RE: BALLY GROUND WATER CONTAMINATION SUPERFUND SITE

EPA is in receipt of the document titled, "Facility Subslab Vapor Analytical results, Former Bally Engineered Structures Facility", dated June 30, 2005. The document was prepared by Arcadis G&M, Inc. (Arcadis).

SUBJECT: Bally Groundwater Site (Document # 25107)
Data Validation Report

FORMER BES FACILITY
SUBSLAB SAMPLE RESULTS
2004 AND MARCH 2005

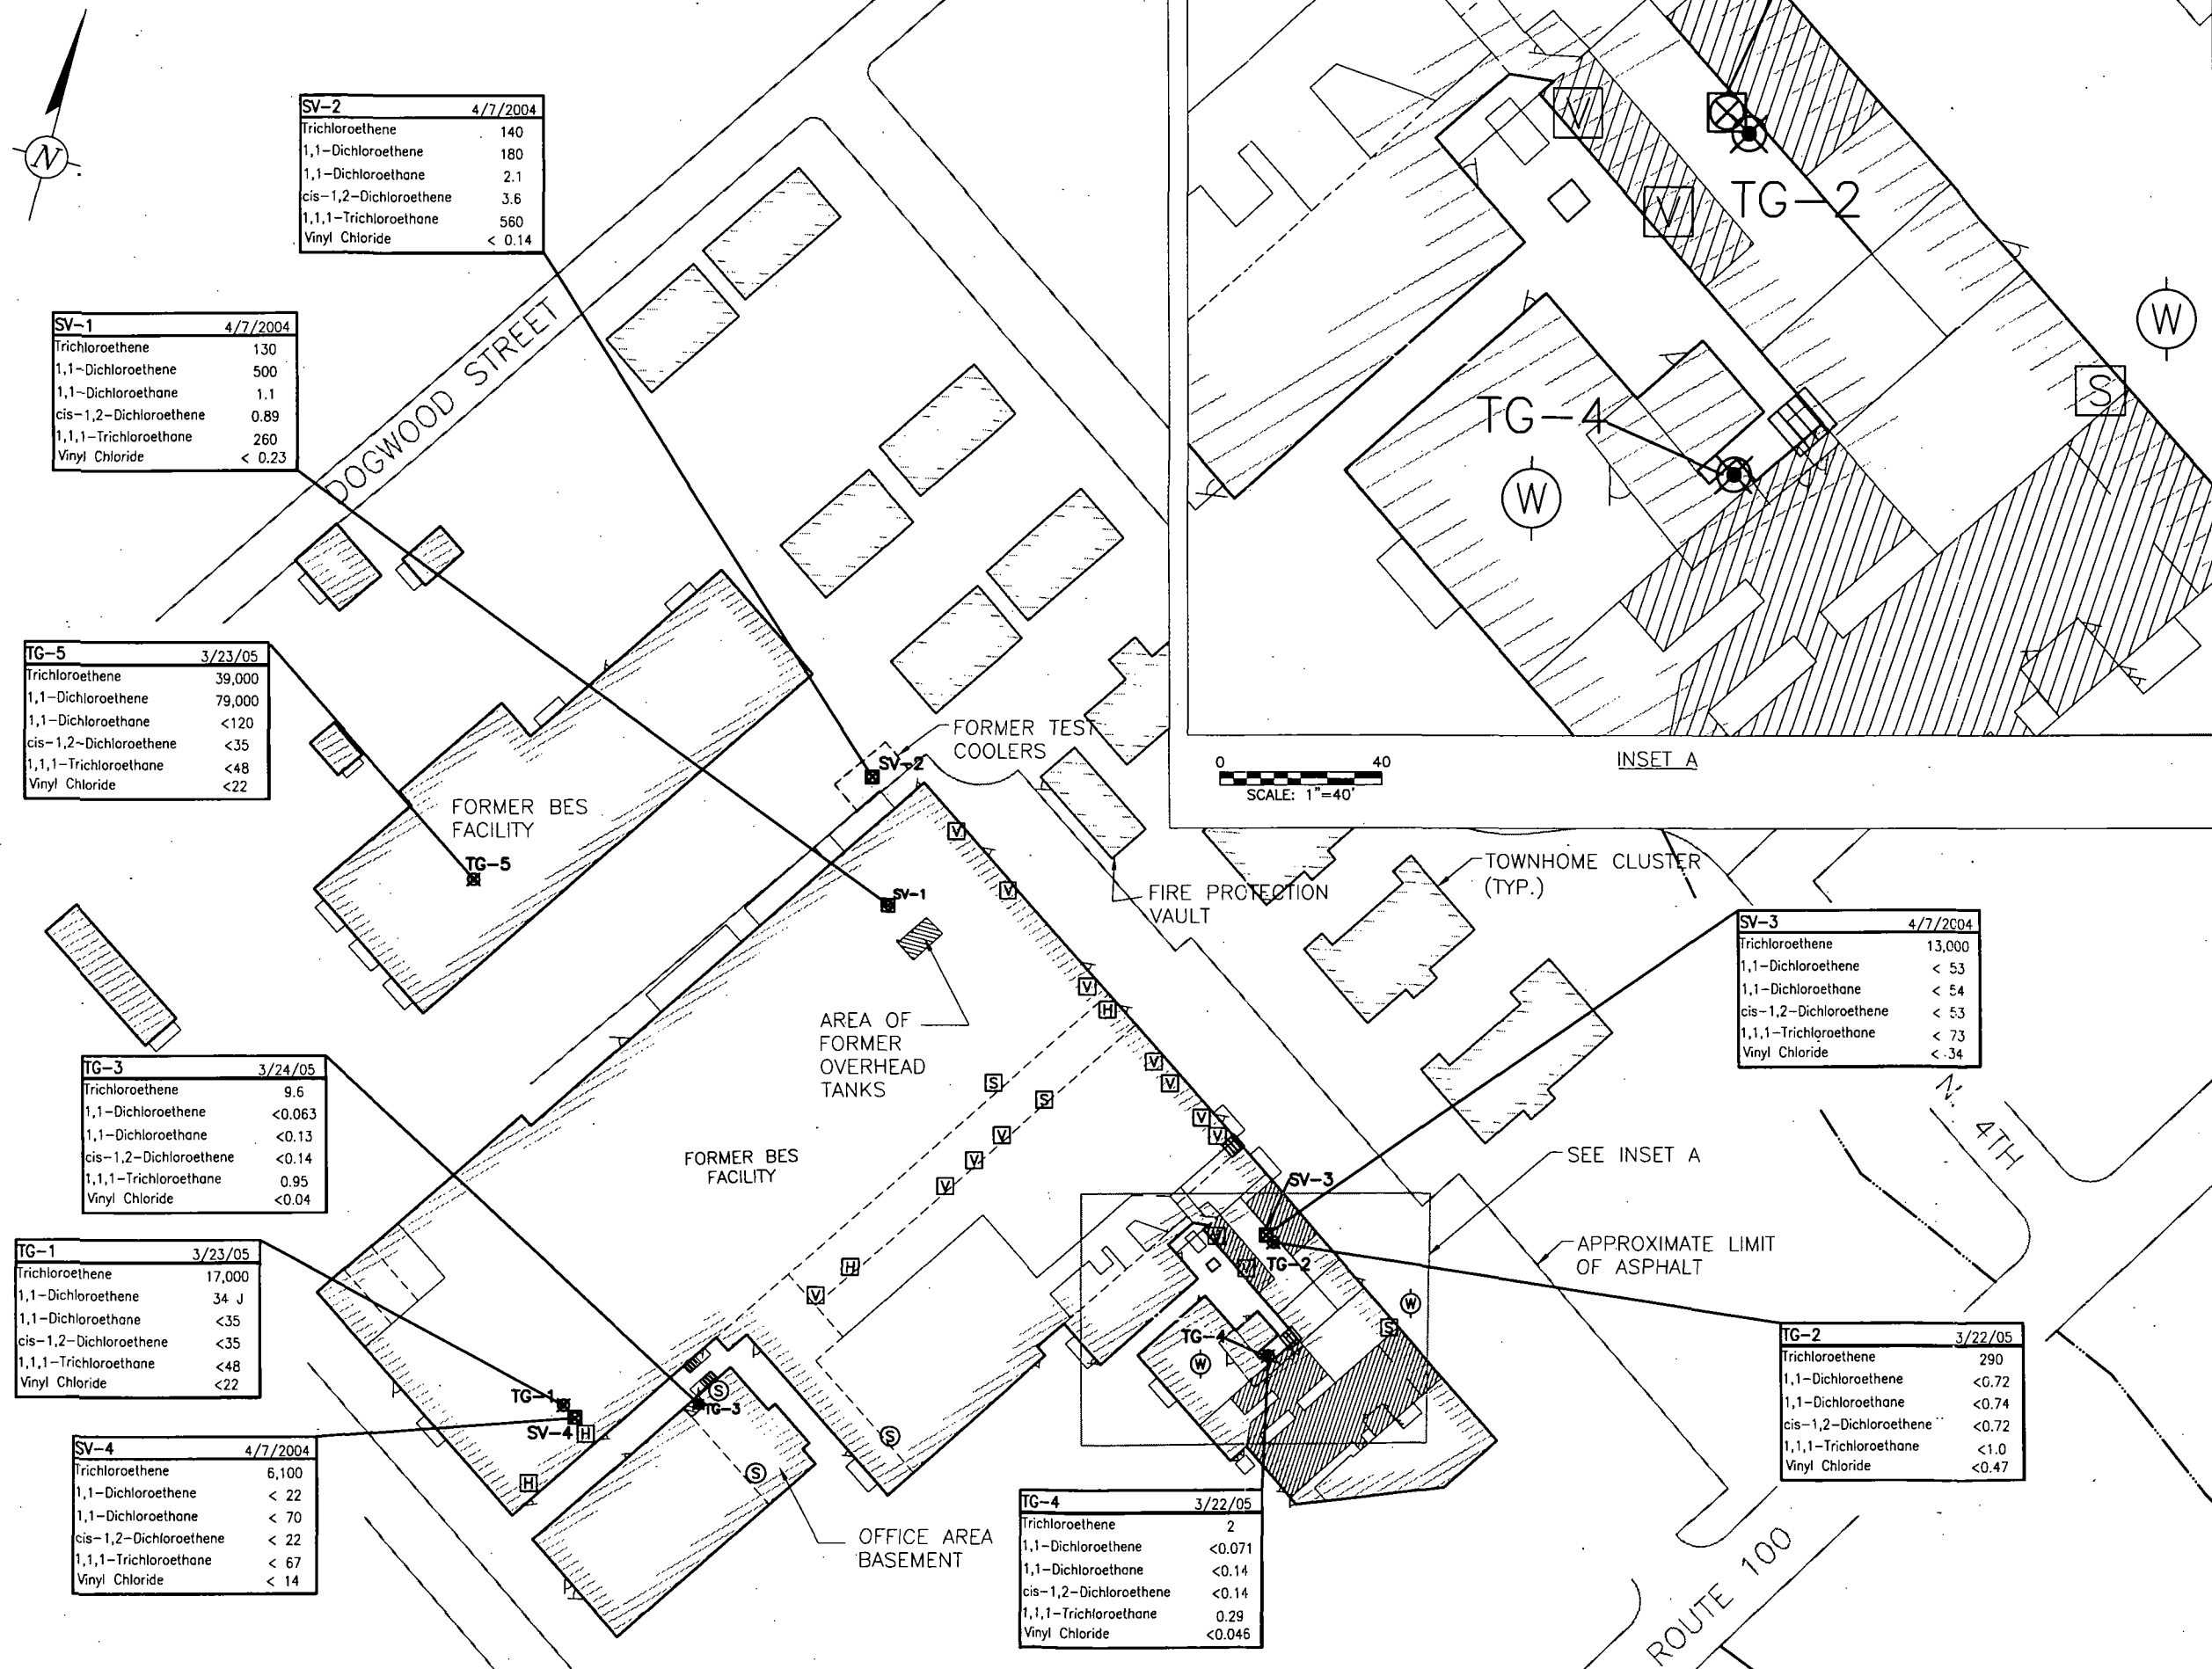
2. In 2004, subslab vapor sample "SW-3" was collected at the same location as the 2005 subslab vapor sample "TG-2". The trichloroethylene (TCE) result for SV-3 (collected 2004) was 13,000 micrograms per cubic meter ($\mu\text{g}/\text{m}^3$). The result for TG-2 (collected 2005) was 290 $\mu\text{g}/\text{m}^3$. Is it possible that the operation of the RAD-7 disrupted the subslab environment prior to subslab vapor sample collection, resulting in the substantially lower TCE result? Also, does this possibility call into question the validity of the analytical result at subslab vapor sample "TG-4"?

3. The subslab vapor sample "TG-5" was collected at the Northwest building. The analytical result for this sample exhibit the highest concentrations of Site-related compounds identified during the vapor intrusion investigation (TCE - 39,000 $\mu\text{g}/\text{m}^3$, 1,1-dichloroethene (DCE) - 79,000 $\mu\text{g}/\text{m}^3$). Is it possible that this area represents an active source of contamination at the Bally Ground Water Contamination Superfund Site? How could this possibility be evaluated?

These results suggest that the areas of greatest concern were in the TG-1 and TG-5/55 vicinity.

The original sample SV-3 was obtained near TG-2. The combination of concentrations and attenuations factors in TG-2 and TG-4 do not indicate a great concern for that part of the building using current data. However, the earlier sample SV-3 had a much higher subslab concentration (13000 ug/m3, vs. the TG-2 concentration of 290 ug/m3). Until the reason for this disparity can be resolved, this area also warrants consideration.

If the attenuation factor of 0.002 applies to the vicinity of SV-1 and SV-2 also, then concerns are reduced for that area. The TG-3 area, which was only sampled once, did not yield results that would warrant great concern (cancer risk at most $1E-5$).
